STAFF REPORT

FILE NUMBERS: 247-22-000812-CU / 247-22-000813-SP

REQUEST: The applicant requests conditional use and site plan approval for a recreation-oriented facility ("ROF") requiring large acreage. Specifically, the ROF will include four (4) outdoor motocross course/tracks.

Figure 4 – Cline Falls Airpark Noise Impact Boundary (Pink) & Subject Property (Red)

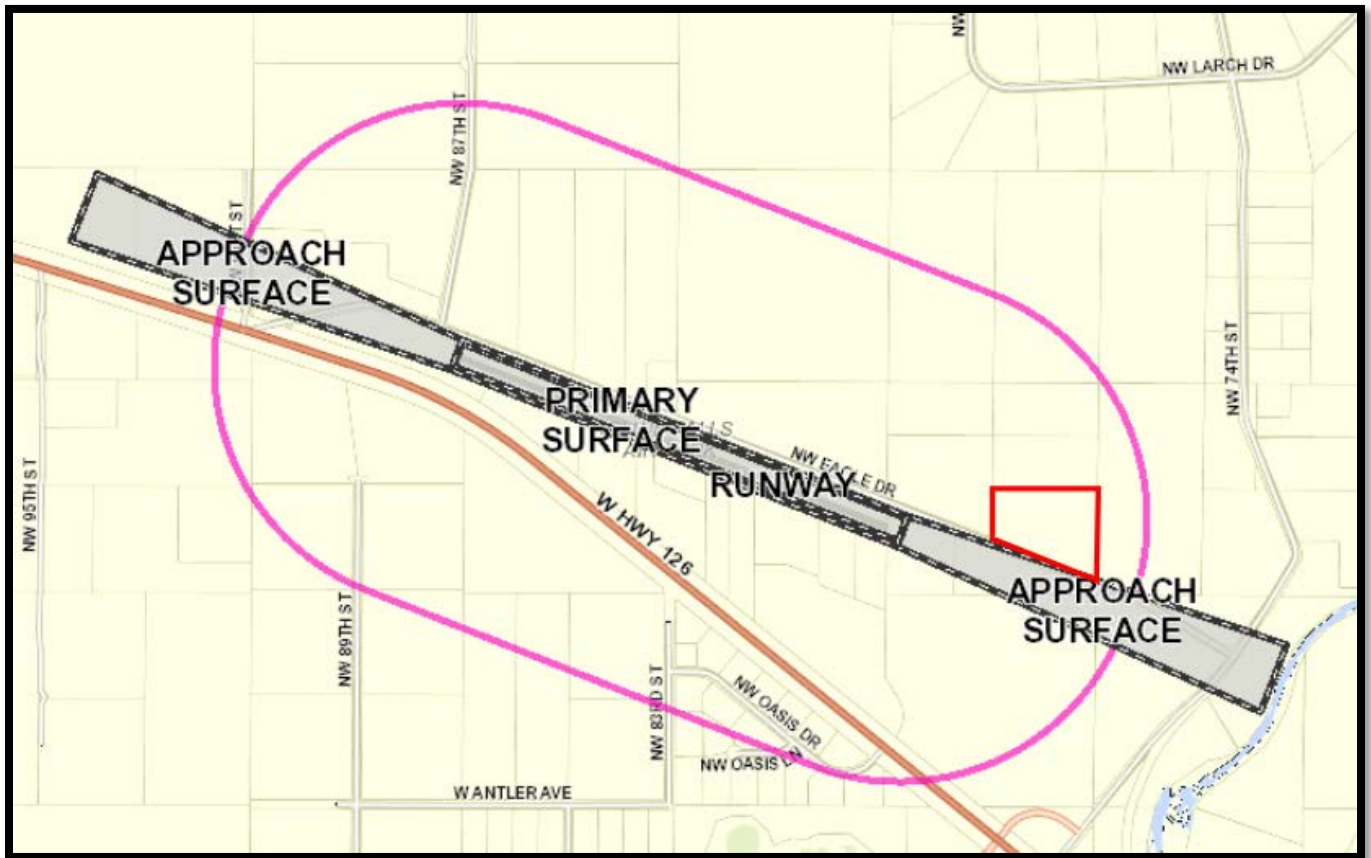
FINDING: The subject property is not located under any of the imaginary surfaces for the Cline Falls Airpark. However, the subject property is located within the Noise impact Boundary for the Cline Falls Airpark (see *Figure 4* below). Therefore, the provisions of this chapter apply.
